NEI 99-02 Appendices F & G

Summary of Changes Incorporated into 9/27/05 Final Draft

APPENDIX F

**METHODOLOGIES FOR COMPUTING THE UNAVAILABILITY INDEX, THE
UNRELIABILITY INDEX AND COMPONENT PERFORMANCE LIMITS**

Figure F-1

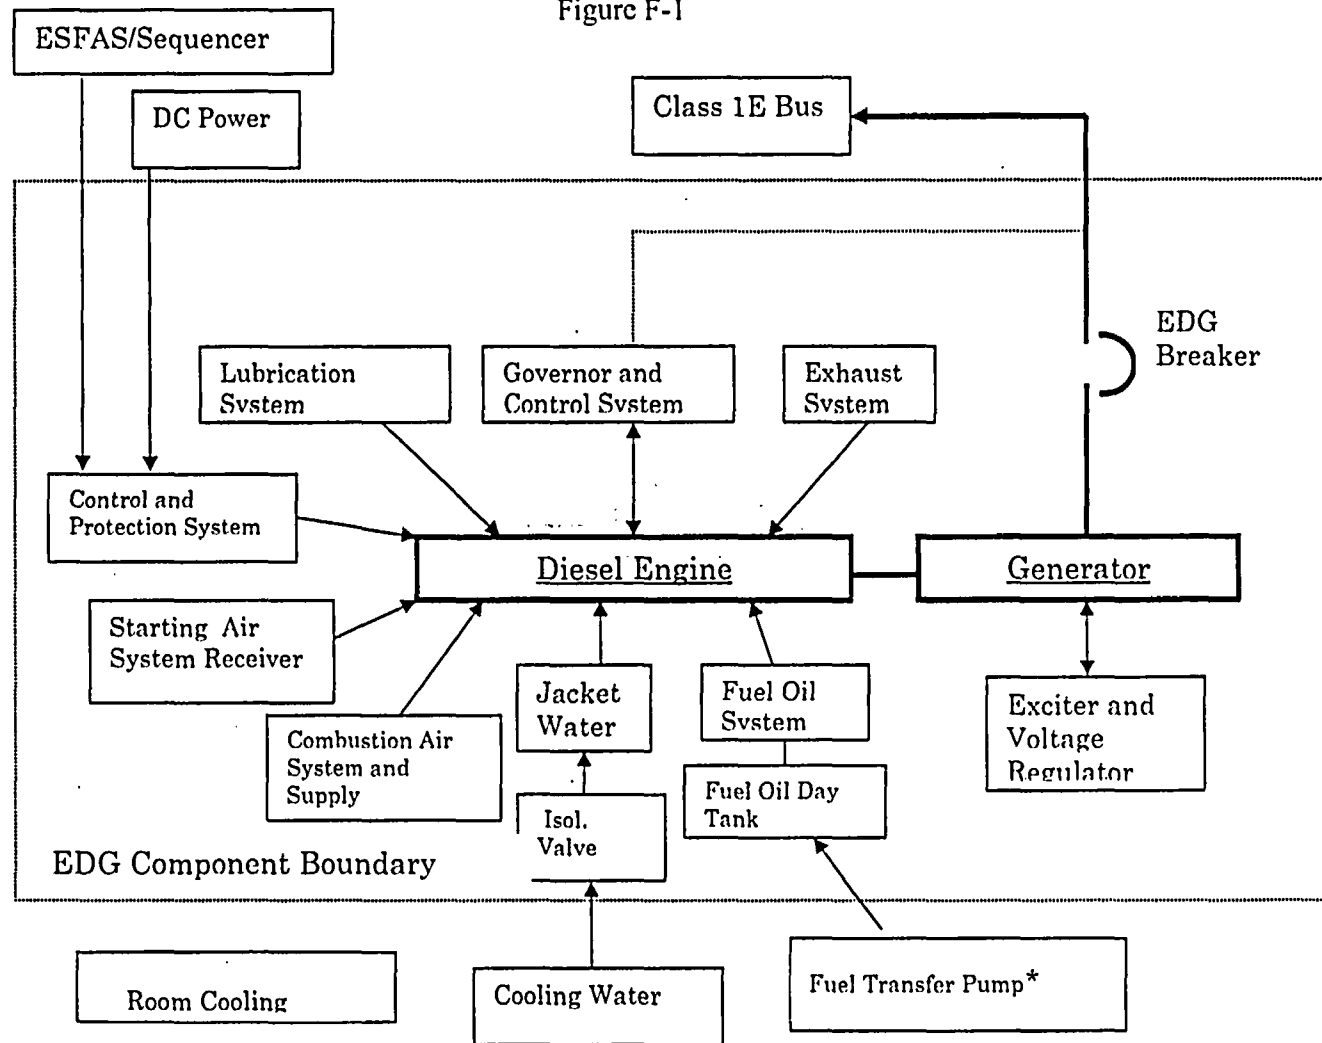
Page	Change Summary	Change Impact to Basis Document
F18	Clarified the component boundary scope for the EDG component to include cooling water isolation valves.	Review current EDG system and component definitions. If cooling water isolation valves are monitored separately from the EDG, then remove them from separate monitoring and include them within the scope of the EDG component.
F19	Added qualifier on run hours and demand estimates. "use best judgment" to split operational and test demand and run time data.	None
F20	Clarified that the 25% criteria for changes in the number of demands or run hours applies to the total for a group of components not an individual component to avoid unnecessary revisions to the basis document. This is justified because the data is pooled anyway.	None
F21 –F22	Revised the section on discovered conditions to address the question of annunciated failures and clarify the treatment of different failure modes.	None
